Our Ref: Haverhill6/049/IJ
21st December 2023

Re: Submission of amended details for Reserved matters application (DC/23/1469/RM) - submission of details under outline planning permission SE/09/1283 - the means of access, appearance, landscaping, layout and scale for the construction of 98 dwellings, together with associated means of enclosure, car parking, vehicle and access arrangements, landscaping and open space for a phase of residential development known as Phase 6. The application includes the submission of details to enable the discharge of conditions B4, B8, B9, B16, B17, B18, B20, B21, B24 of outline planning permission SE/09/1283.

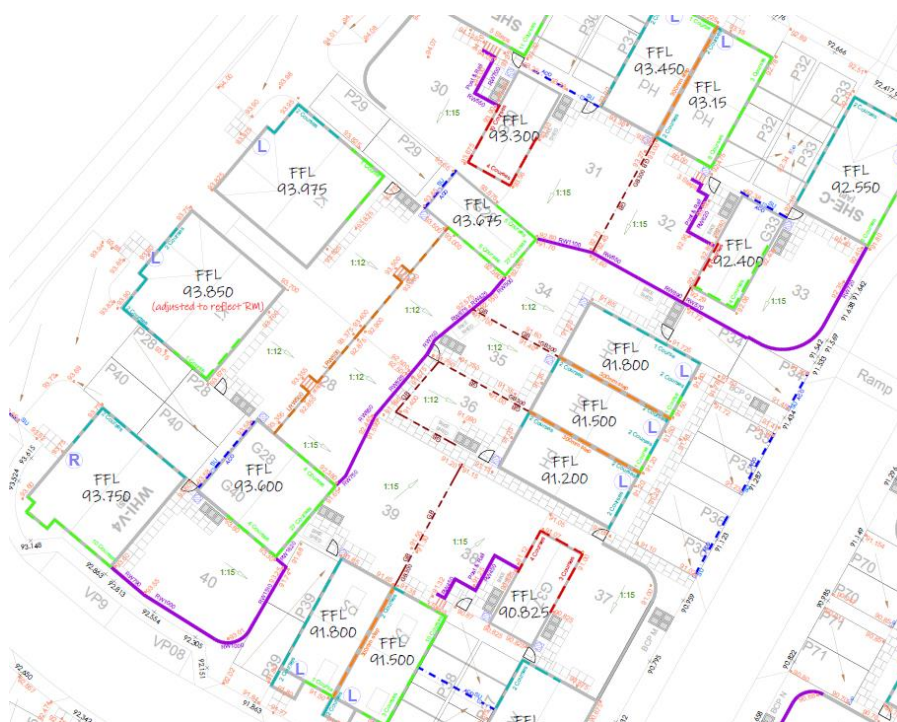
The access to the apartments in the northwest corner has been amended to provide a level access entrance. A section of POS has also been raised by the apartment entrance to provide additional amenity (as shown on amended plans).

Extract from plan titled '049-E-SK220 Plot 28-29 Garden Retaining walls Rev A

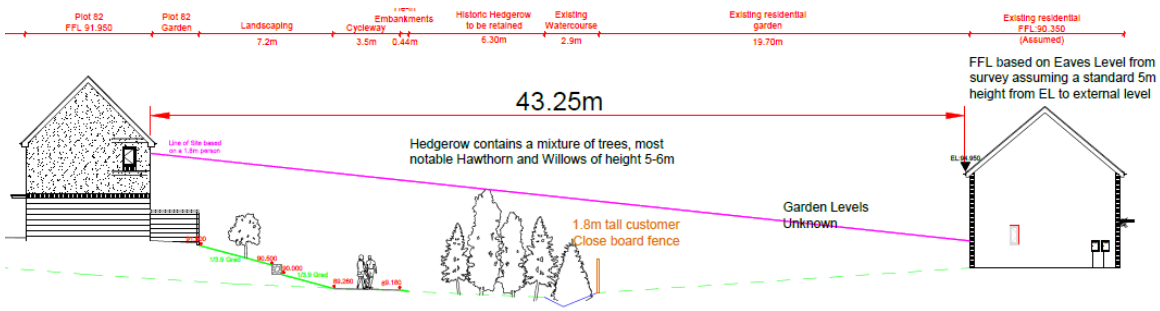
As requested by planning officers, the heights of retaining walls in gardens of plots 23 and 24 have both been reduced by approximately 300mm. The retaining walls for gardens of plots 34-36 have also been significantly reduced following discussions with planning officers.

Extract from plan titled '049-E-SK211 Eastern Boundary Cross Sections Sheet 1' showing screening of plot 82.

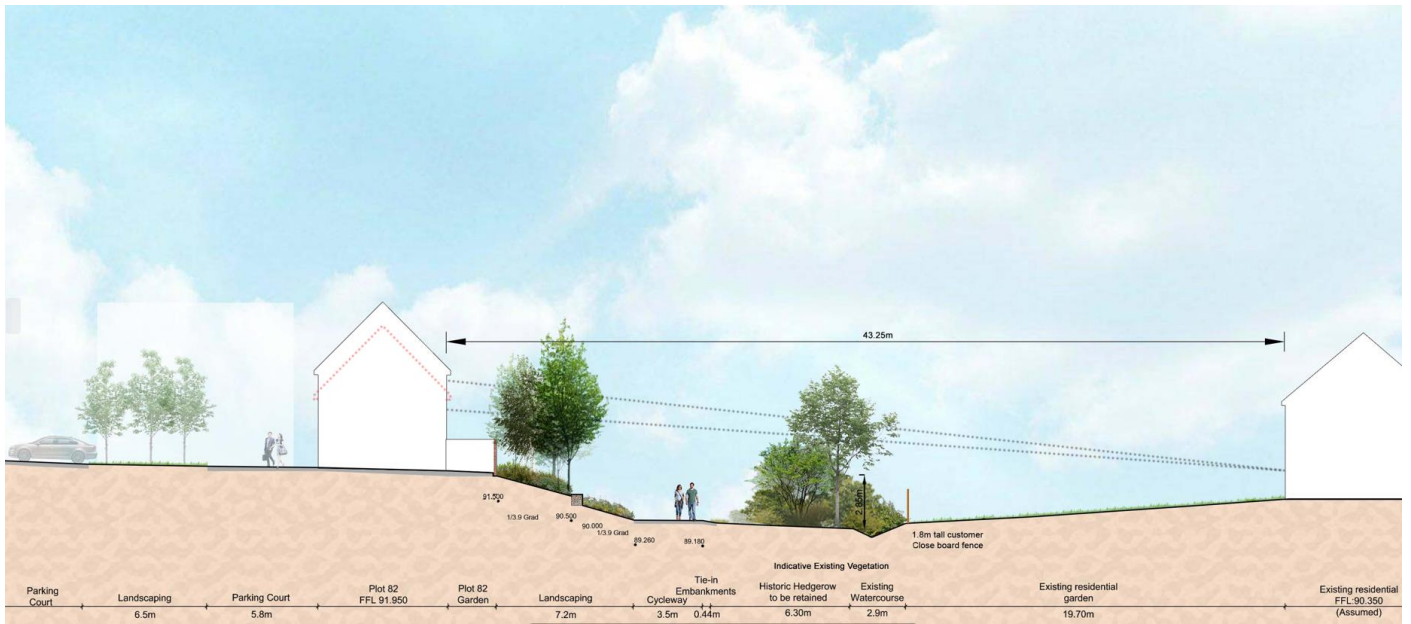
The distance between the FOG (plot 82) and existing properties is sufficient, where it has been agreed with officers that additional planting successfully screen the views of existing properties so as not to impact residential amenity or privacy (as shown with section B-B below). Additional planting has also been provided to the west of the gabion baskets.

Extracts of approved landscaping (left) and proposed amendments (right)

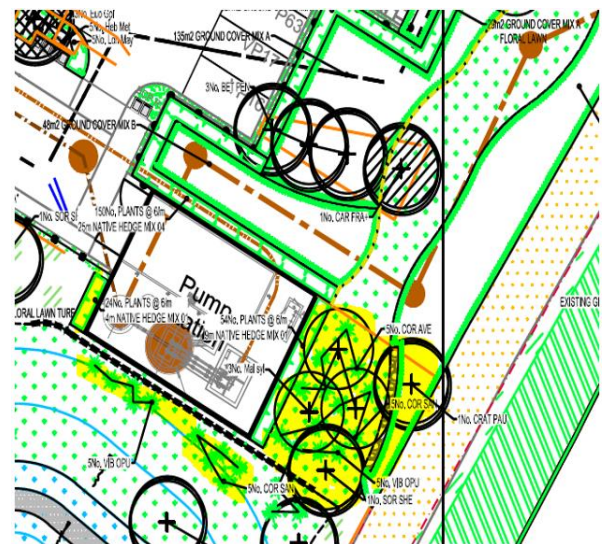
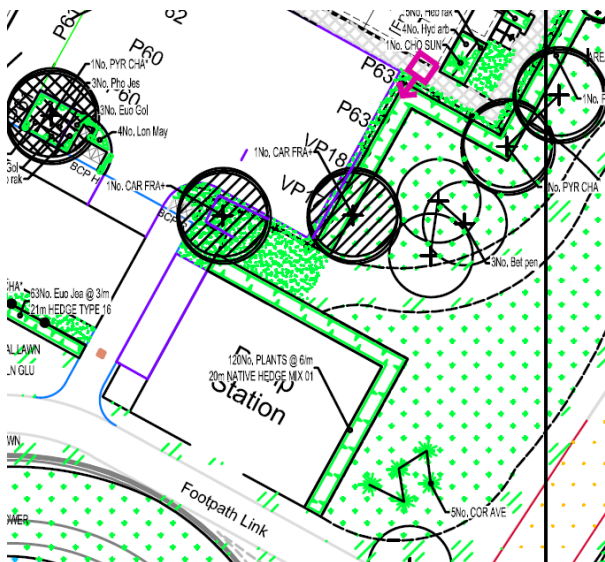
As shown in the images above, landscaping west of the footpath/ cycleway has been further enhanced through additional shrub and ground cover mix planting (additional planting highlighted in yellow). Two sections of Gabion Basket retaining walls have been included, providing further planting opportunities by improving the amenity of the planted area.

Extracts of approved landscaping (left) and proposed amendments (right)

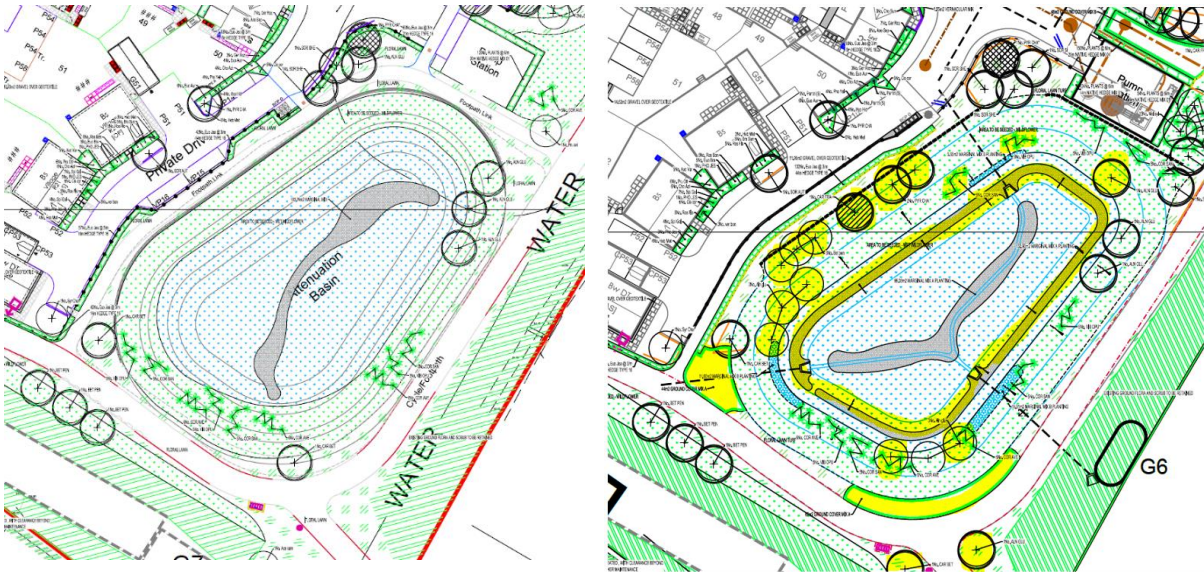
Planting surrounding the pump station has been further enhanced, with the addition of gabion basket retaining walls with shrub planting both sides.

Extracts of approved landscaping (left) and proposed amendments (right)

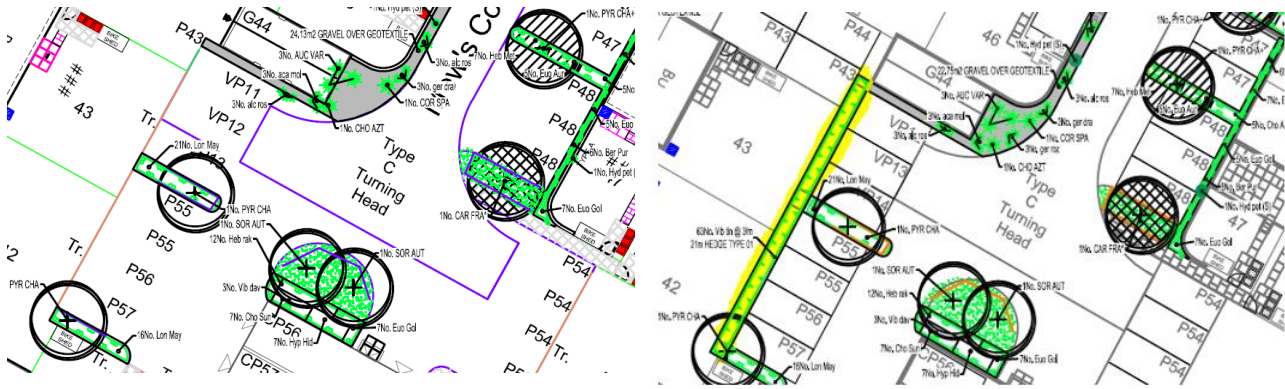
The basin area has been enhanced as the basin retaining wall can be designed as separate and smaller retaining walls, which will be less intrusive and present a more natural and softer edge to the development and further planting is proposed to be incorporated. The footpath that was north of the basin has been removed to allow for additional landscaped area to screen the pump station. Additional shrub planting has also been provided around the SUD basin, improving its amenity (additional planting highlighted in yellow in above image).

The retaining wall surrounding the basin will be constructed using Tobermore retaining wall materials, providing a more natural aesthetic than regular retaining walls, further enhancing the amenity of the area.

Extract of proposed landscaping plan

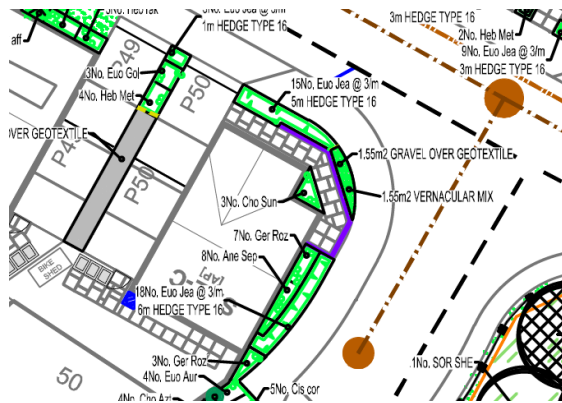
Further amendments are also proposed within the site to further enhance the landscape scheme of this phase, which includes additional hedge planting in the parking courts to the east of plots 42 and 43 (see planting highlighted in above image).

Extract of proposed landscaping plan

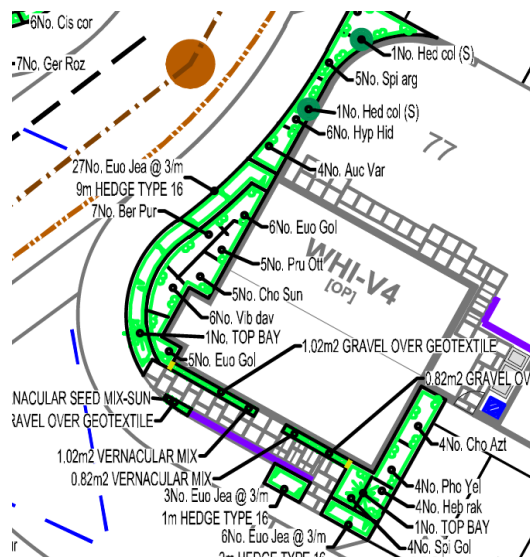
To comply with M4(1) building regulations, a stepped free approach to the principal access must be provided where possible, which has resulted in the provision of a ramp (As requested by Councillor Mason). To ensure continuation of the green frontage, shrub planting has been retained in front of the retaining wall and facing the road. Ivy has also been included in front of the retaining wall, making it a green wall, and providing visual amenity
